Quality Assurance and Source Inspection

Contract #: 04-0120F4Cty: SF/ALA Rte: 80 PM: 13.2/13.9File #: 69.25B**QUALITY ASSURANCE -- NON-CONFORMANCE REPORT****Location:** Changxing Island, Shanghai, P.R. China**Report No:** NCR-000286**Prime Contractor:** American Bridge/Fluor Enterprises, a JV**Date:** 27-May-2009**Submitting Contractor:** Zhenhua Port Machinery Company, Ltd (ZPMC), Changxing Island**NCR #:** ZPMC-0260**Type of problem:****Welding****Concrete****Other****Welding****Curing****Procedural****Bridge No:** 34-0006**Joint fit-up****Coating****Other****Component:** FB014-003, Segment 3AE**Procedural****Procedural****Description:****Reference Description:** Unapproved Heat Straightening, Segment 3AE**Description of Non-Conformance:**

Job Name: SAS Superstructure
Document No: 05.03.06-000251

Reference Description: Unapproved Heat Straightening, Segment 3AE

Heat Straightening Record(HSR1)

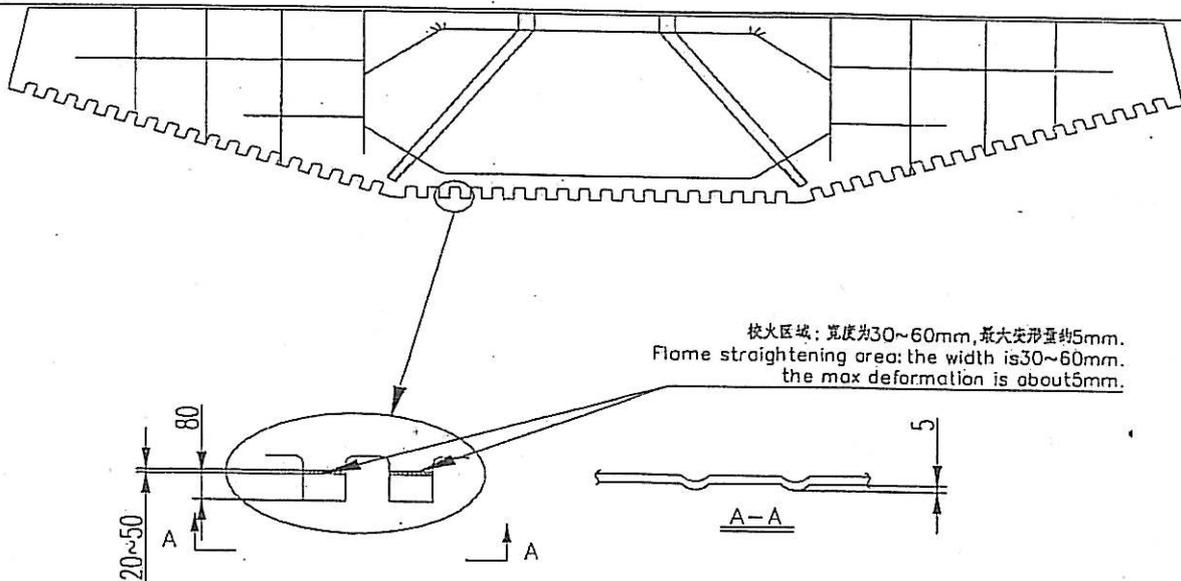
情况描述 Description of Condition

Cause 原因 Welding distortion 焊接变形

Type of Defect 缺陷类型 Welding distortion 焊接变形

After finishing heat straightening, the weld of the heat area shall perform NDT according to the approved shop drawing 校火后, 根据图纸要求对热影响区域进行 NDT 检测。

Control current, voltage and weld speed according to relevant WPS. If necessary anti-deformation or hold down device can be added. 依据相应的 WPS 的要求控制电流, 电压和焊接速度。如有必要,

实施次数(Number of application): 1~3

最高温度(Maximum temperature): <650°C
